IN THE DRAWINGS:

REMARKS

This is intended as a full and complete response to the Office Action dated June 25, 2007, having a shortened statutory period for response set to expire on September 25, 2007. Claims 1-20 are pending in the application. By way of this reply, Applicants are amending claims 1, 9, and 16, canceling claims 6, 7, 13, 14, and 18, and adding claims 21-25.

Fig. 5A

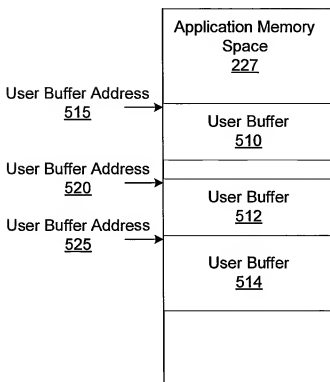
The attached sheets of drawings include changes to Figures 5A, 10A, and 10B. The first attached sheet including Figures 5A and 5B replaces the original sheet including Figures 5A and 5B. "Application Memory Space 225" in Figure 5A has been changed to "Application Memory Space 227" to match the description in paragraph [0061] of the specification. The second attached sheet including Figures 10A and 10B replaces the original sheet including Figures 10A and 10B. Figures 10A and 10B have each been amended to include text labels.
